CENTER FOR ELECTRONIC WATCHES, Division of  
**HAMILTON WATCH CO., INC.**  
LANCASTER, PENNSYLVANIA 17604, U.S.A. (717)394-7161

October 31, 1977

REF: File No. 89036, FCMS:RLB:PC, your letter of September 20, 1977.

In reference to your letter dated September 20, 1977, please find below the appropriate answers to your questions.

Fig. 1

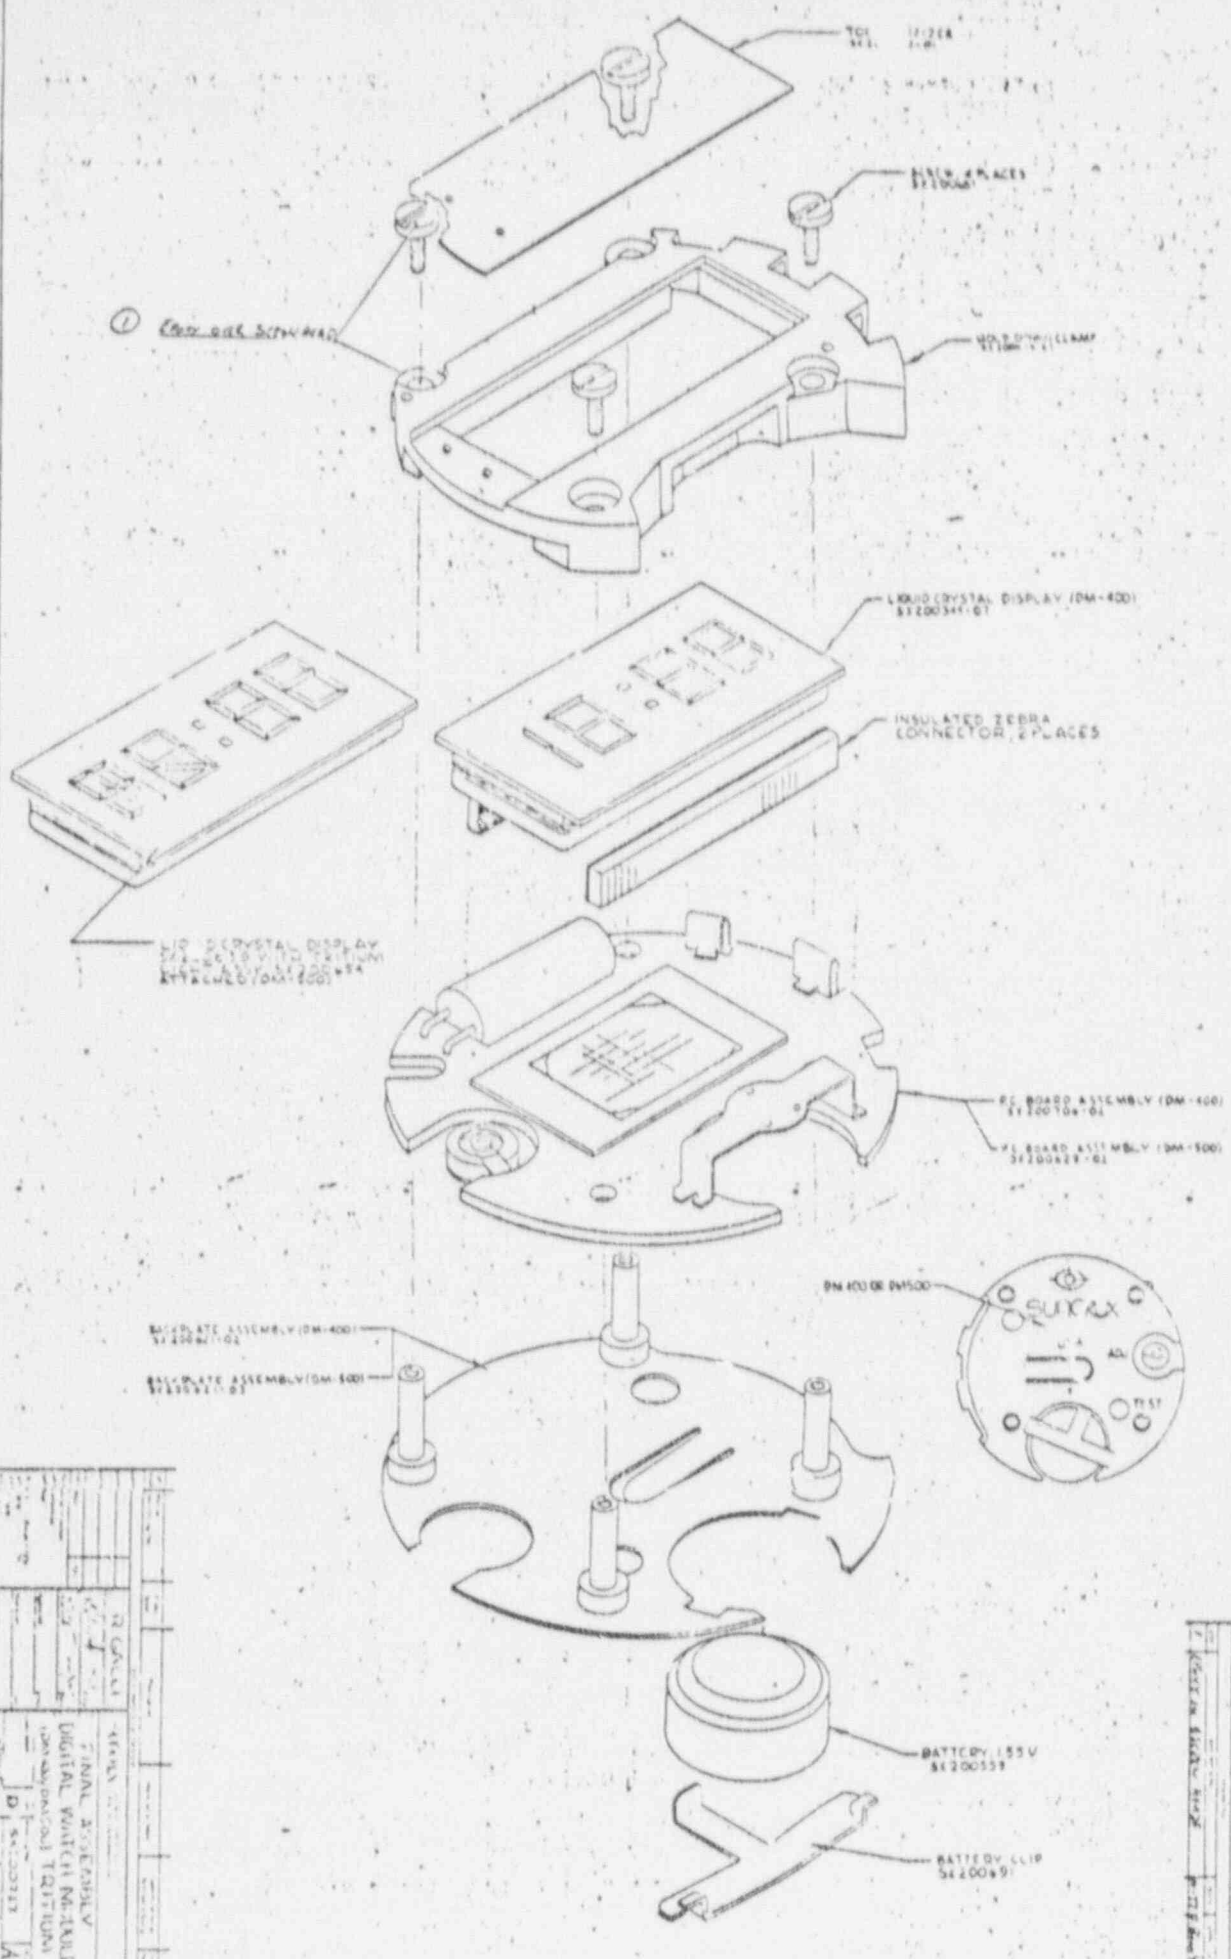
Question 4.

Access to the tritium luminous sources is restricted by the presence of both RTV silicone rubber encapsulant around the tritium source, and an epoxy seal between the back pan and the LCD display. The pan is therefore glued to the backside of the display. Access is

further restricted by assembly into the module shown on figure 1. The tritium display light assembly cannot be removed through the front of the module without destruction of the module. The display is retained in the module by a plastic lip around the perimeter of the display opening. The assembled module is forcibly inserted into the watch case by means of a press fit. Disassembly of the module by removal of the assembly screws is impeded by covering the complete four screw heads with epoxy to the display frame. Enclosed photograph shows the epoxy seal on top of the four screw heads and display frame. Also enclosed alteration done on print #SX200727, Revision A. The epoxy used shall be extremely hard, and shall therefore not be removed by any tool.
